Advisory Notice for Titan T-51 Mustang Aircraft

March 4, 2009

Service recommended before any further flights

MATERIAL		DETAIL NAME AS NOTED	
DRAWN B. HODGKINSON	DATE 8-25-03	SCALE 1/4"=1"	PART NO. AS NOTED
CHECKED	DATE	ASSEMBLY NAME TAILWHEEL INSTALLATION INSTRUCTIONAL	
APPROVED	DATE	PART NO.	DRAWING NO.
		DRAWING NO. B T51-03-INS-0816-E

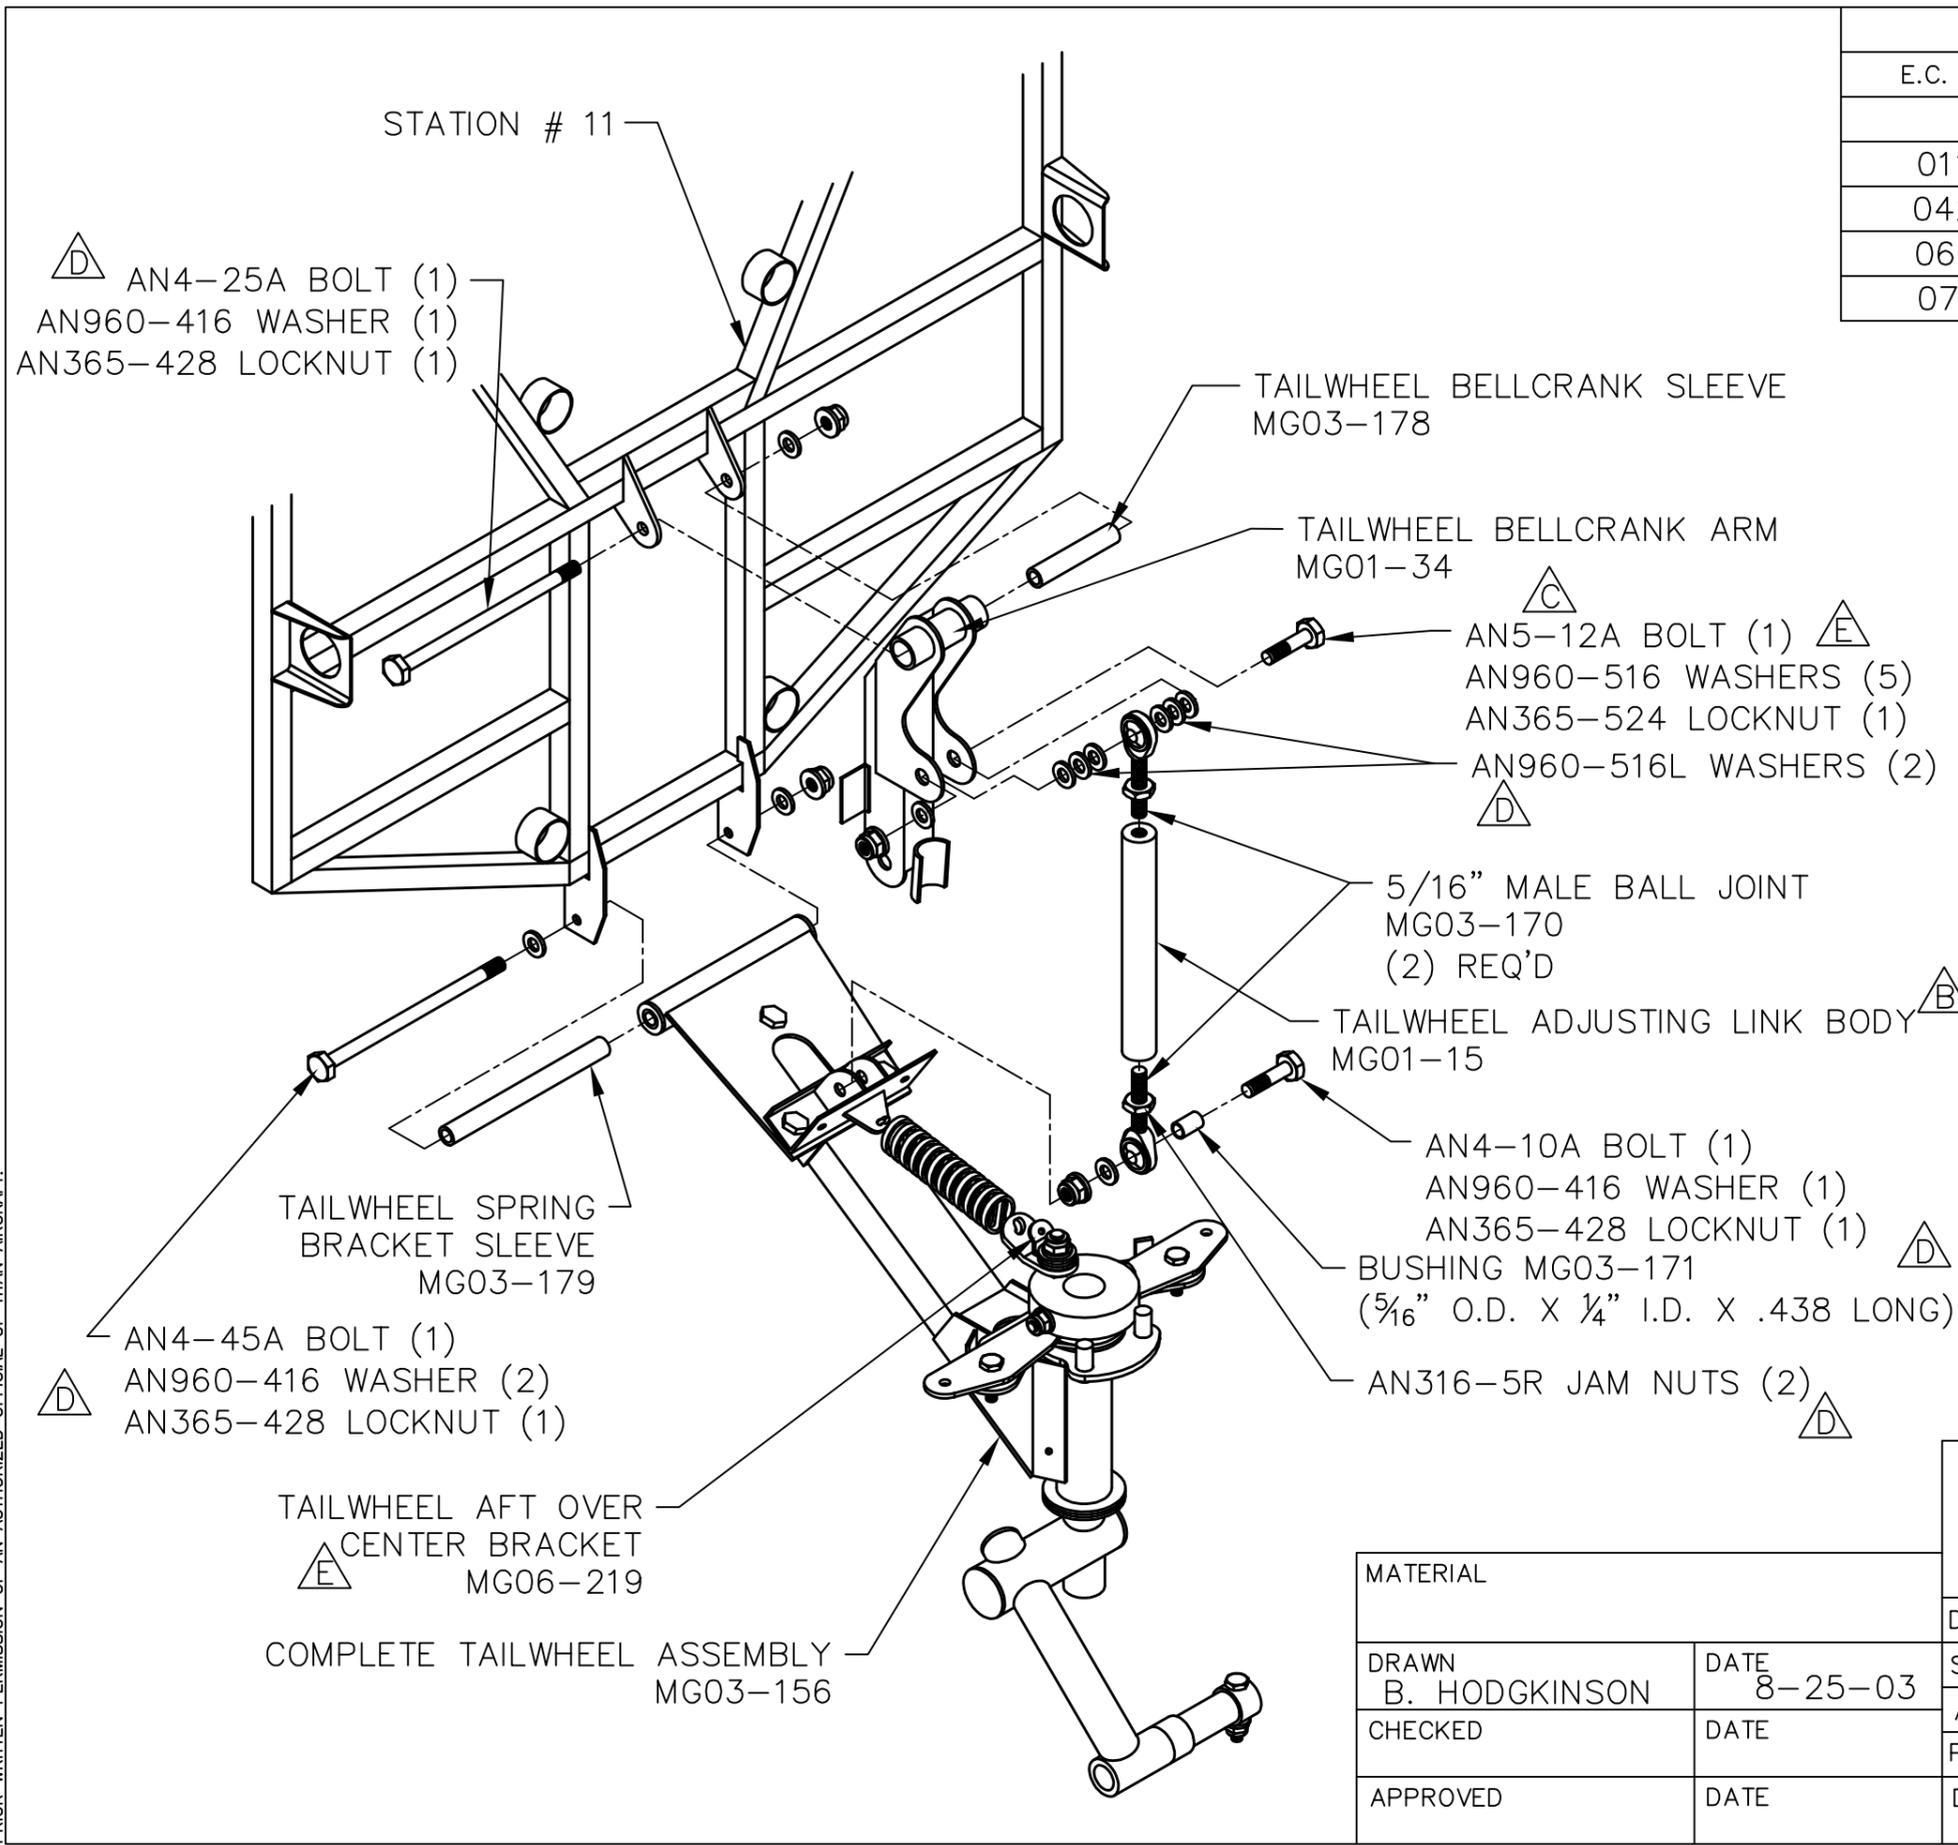
An aircraft, with approximately 150 hours of service on a rough grass field, was found to have the support tube at station #11 twisted. This caused the tailwheel to retract while the aircraft was landing, resulting in damage to the gear doors.

Using the aft baggage compartment opening, inspect station #11 to see if there is a second tube welded in place above the over center support bracket tube, as shown on the attached drawing number T51-03-INS-0816-E. If there a second tube no further action is required, if not, see below.

DETAIL NAME ELEVATOR BELLCRANK STIFFENER INSTALLATION	
SCALE 1/4"=1"	PART NO.
ASSEMBLY NAME	
PART NO.	DRAWING NO. 05
DRAWING NO. B T51-09-INS-1807-A

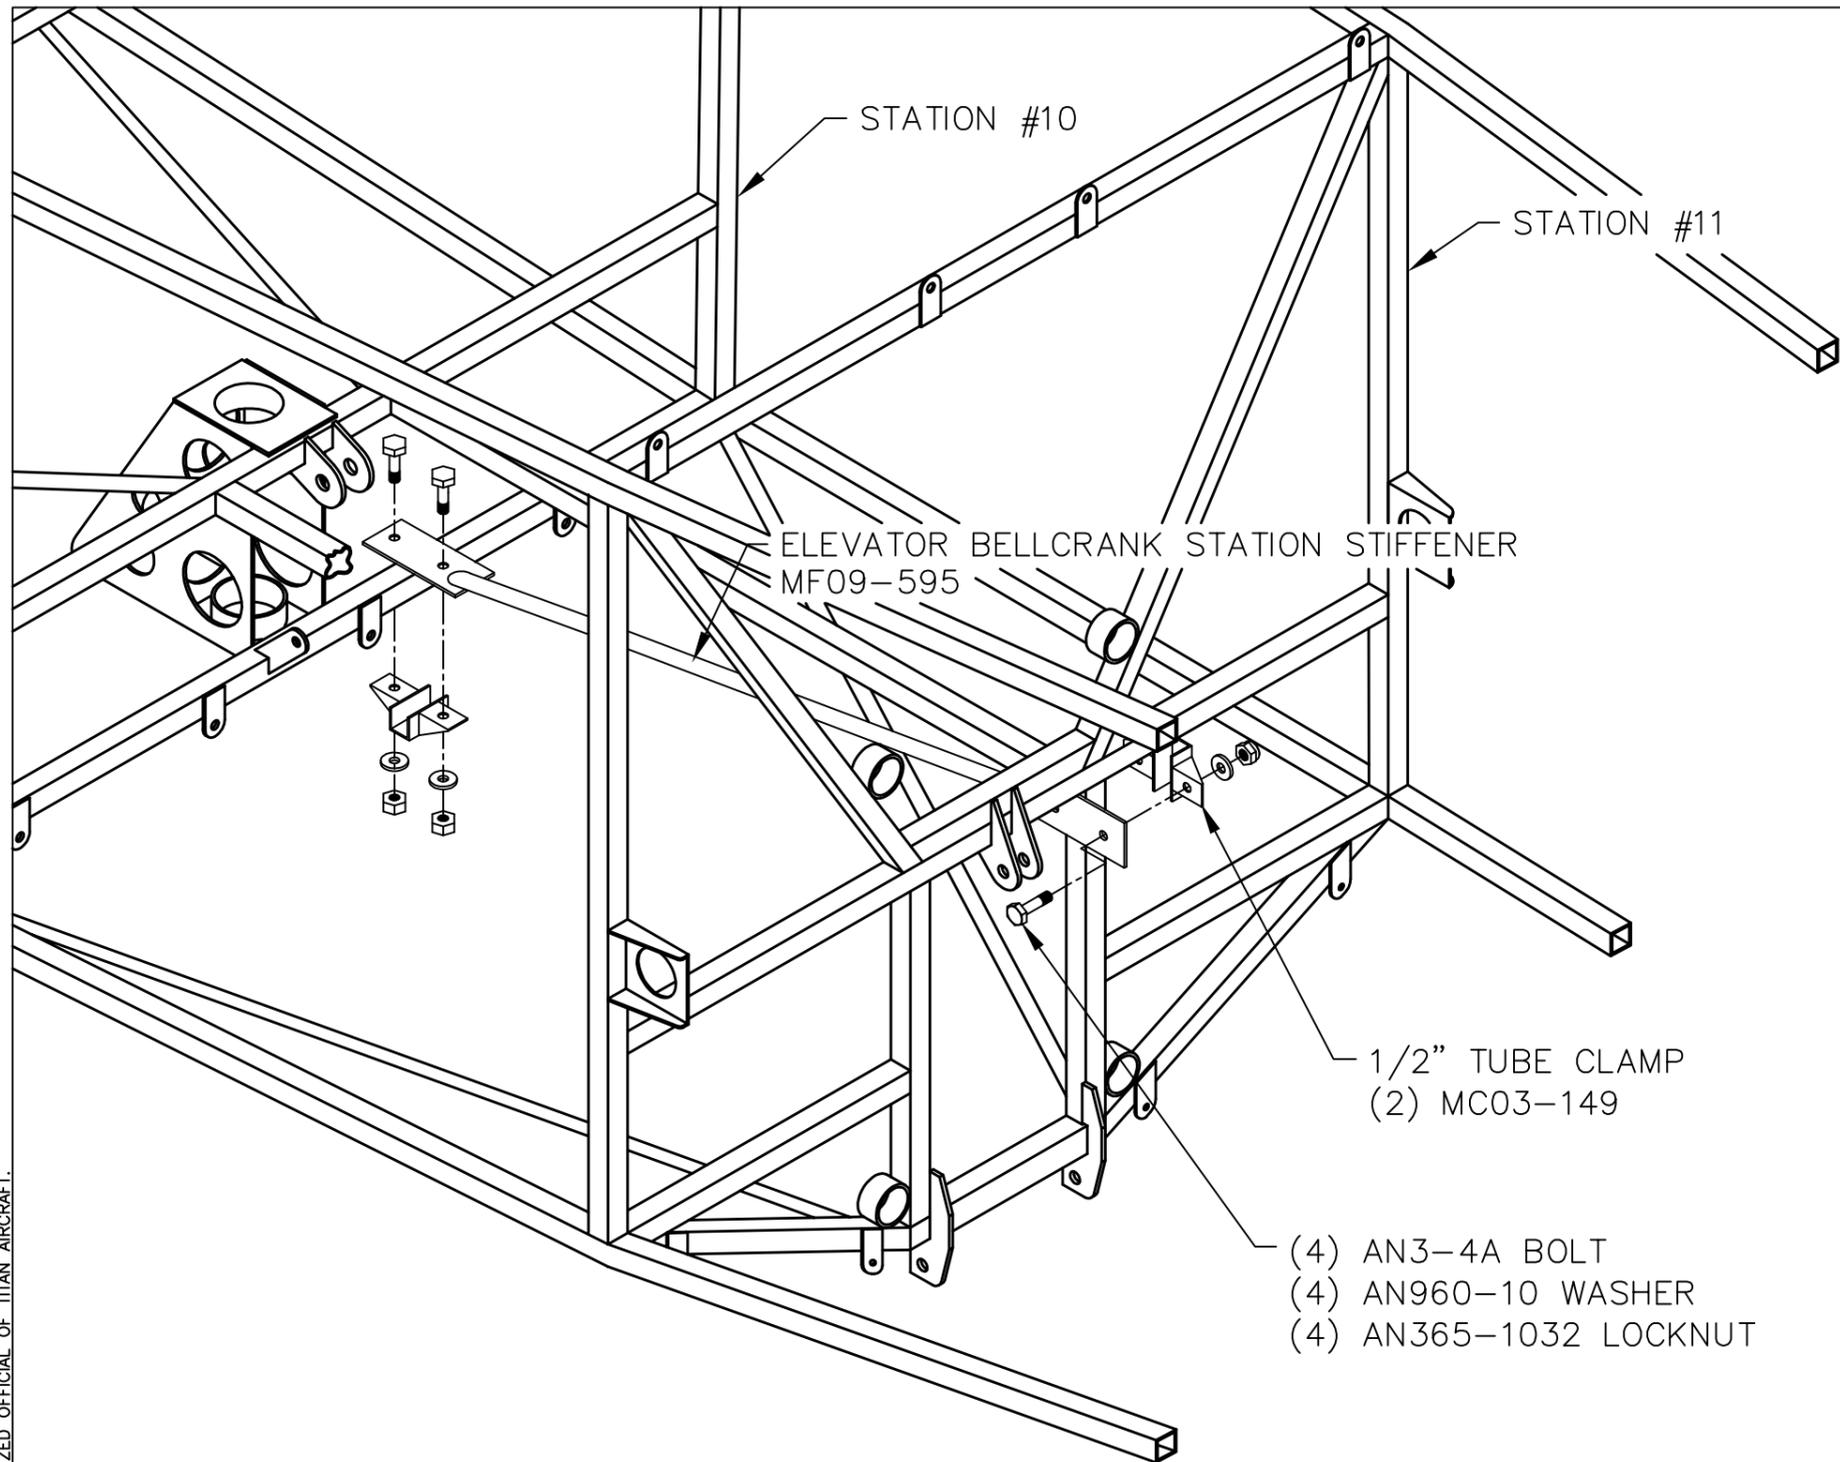
A field modification kit (MC06-293) is available to strengthen station #11. It simply bolts into place to provide the additional support required, as shown on the attached drawing number T51-09-INS-1807-A.

NOTES:
 - POSITION (MF09-595) AS SHOWN IN DRAWING, STIFFENER SHOULD BE LOCATED ON THE RIGHT SIDE OF THE ELEVATOR BELLCRANK, SO IT DOES NOT INTERFERE WITH LIMIT SWITCH.
 - TRIMMING ON LOWER FORMER U10 AND TAILWHEEL FWD ENCLOSURE MAY BE NECESSARY.

- 1/2" TUBE CLAMP
(2) MC03-149
- (4) AN3-4A BOLT
- (4) AN960-10 WASHER
- (4) AN365-1032 LOCKNUT
